# UNITED STATES PATENT AND TRADEMARK OFFICE

APPLICATION NO.	FILING DATE	FIRST NAMED INVENTOR	ATTORNEY DOCKET NO.	CONFIRMATION NO.
10/565,999	10/06/2006	Kiyohiro Shimokawa	285290US3XPCT	9543
22850 7590 02/28/2008 OBLON, SPIVAK, MCCLELLAND MAIER & NEUSTADT, P.C. 1940 DUKE STREET ALEXANDRIA, VA 22314			EXAMINER TRIEU, THAI BA	
			ART UNIT 3748	PAPER NUMBER
			NOTIFICATION DATE 02/28/2008	DELIVERY MODE ELECTRONIC

<b>Office Action Summary</b>	<b>Application No.</b>		<b>Applicant(s)</b>	
	10/565,999		SHIMOKAWA ET AL.	
	<b>Examiner</b>		<b>Art Unit</b>	
	Thai-Ba Trieu		3748

## DETAILED ACTION

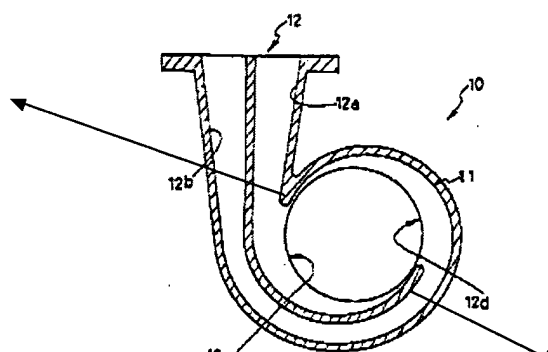
The modified Heydrich/Pierport discloses the invention as recited above; however fails to disclose tongues and their positions

Takeda Toshio/Birmann teaches that it is conventional in the turbocharger art, to utilize tongues (Not Numbered) being respectively provided at two circumferential

positions of the turbine scroll, an exhaust inflow range from the tongue near the exhaust inflow port to the tongue away from the exhaust inflow port providing a throat portion only for one of the flow paths, the remaining exhaust inflow range from the tongue away from the exhaust inflow port back to the tongue near the exhaust inflow port providing a throat portion only for the other flow path (See Figure 1 of Takeda Toshio, Figure 2 of Birmann).

the tongue near the  
exhaust inflow port

the tongue away from the  
exhaust inflow port
